P802.1Qcz D0.4

Paul Congdon
November 2019

Agenda

12.31.2.2 stream_handle specification data type

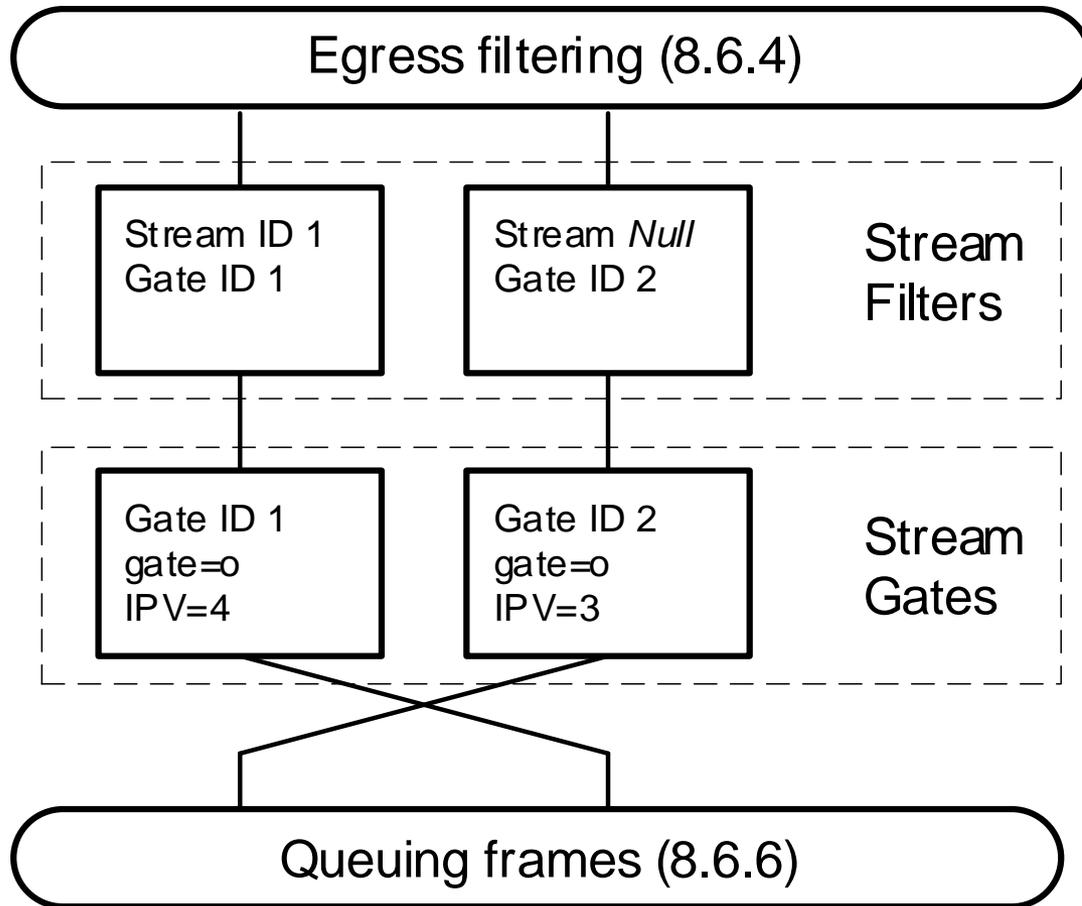
Change the opening list as follows:

The stream_handle specification data type allows either of the following to be represented:

- a) A stream_handle value, represented as an integer.
- b) The wild card value.
- c) [The null value.](#)

Must change MIBs and YANG as well

New Figure 8-16 for CI

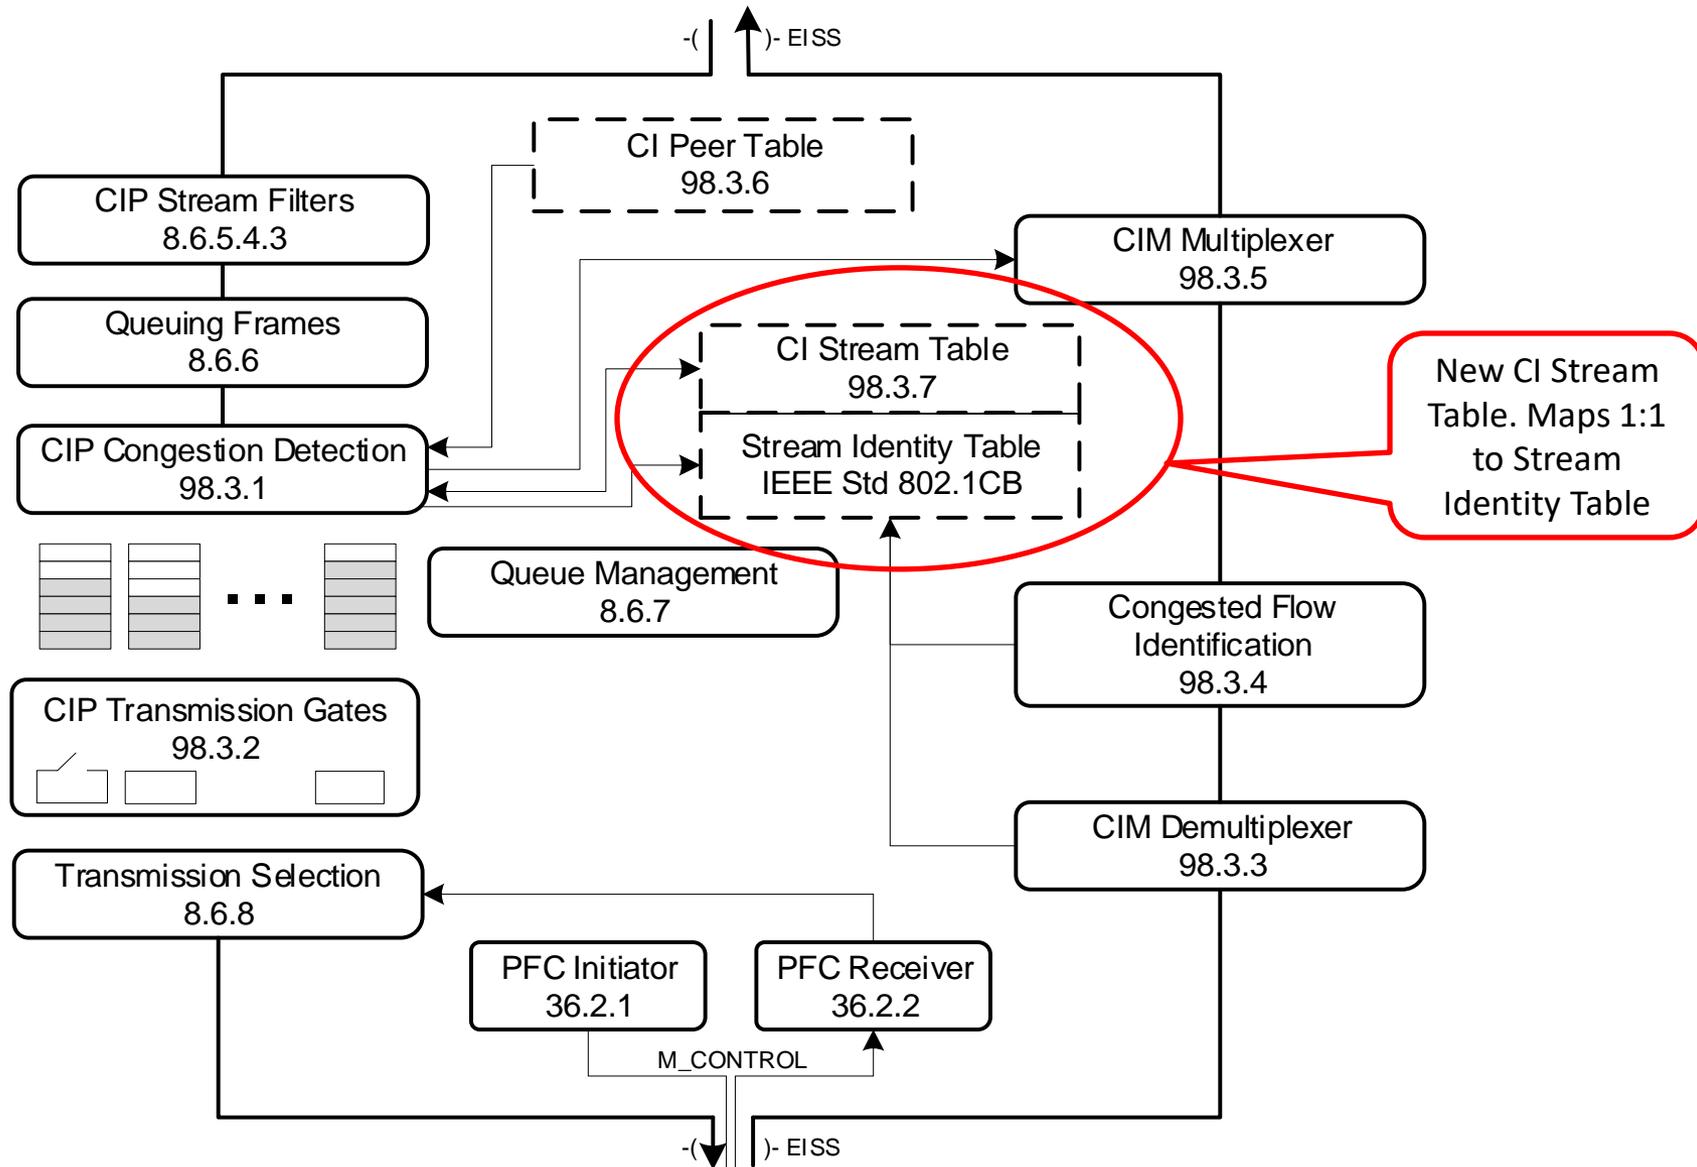
802.1Qcz Reference Diagram

98.4.1.5.3 ciStreamCreateMask

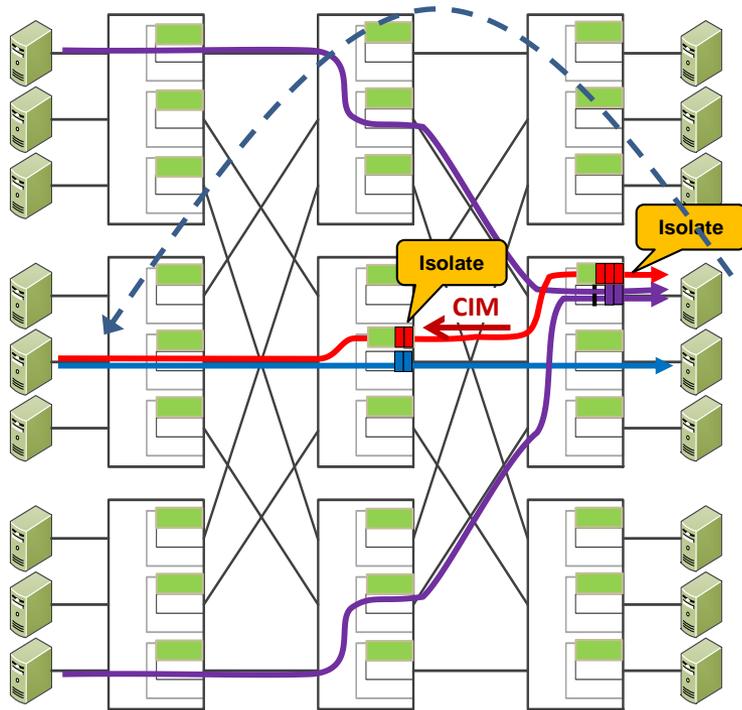
- 2-bit attribute of entries in the CI Stream Table
- LSB = entry created because of local congestion
- MSB = entry created because of receipt of CIM
- Actions:
 - Clear LSB when local congestion subsides
 - Set MSB when CIM received/refreshed
 - Clear MSB when receiving a CIM Del or not refreshed
 - Delete entries when LSB and MSB are clear

1st Choice – Independent 802.1 Organizationally Specific TLV

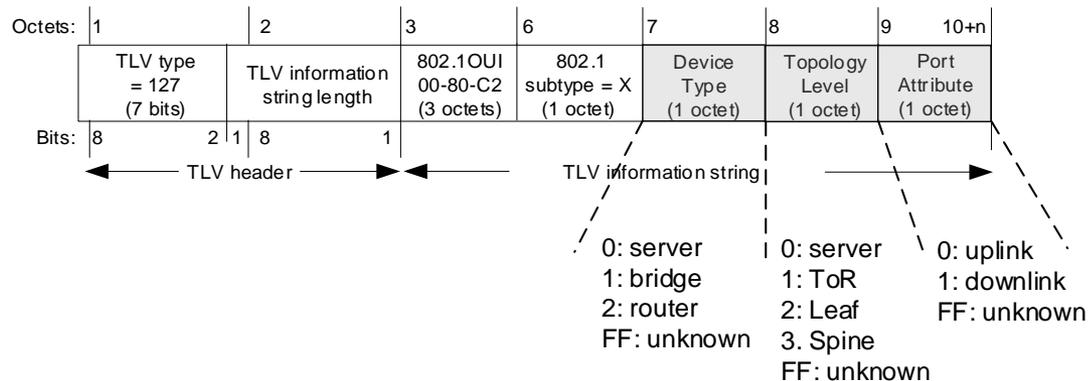
LLDP TLV Proposal

2nd Choice – Include in existing Congestion Isolation TLV

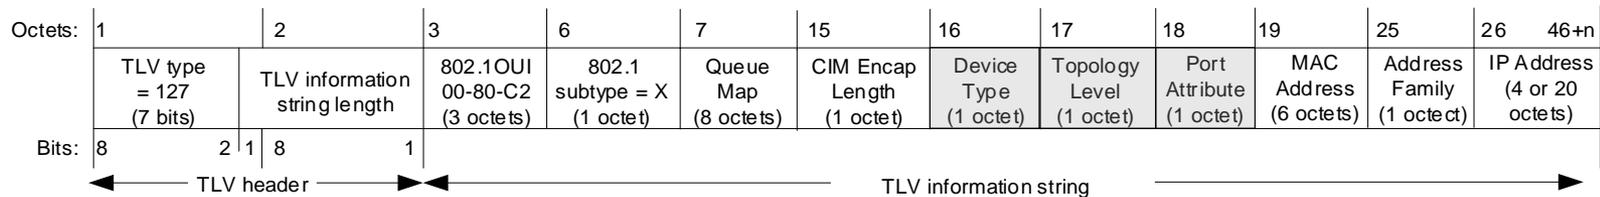
Note: if Topology Recognition is not supported, all new values are 0xff
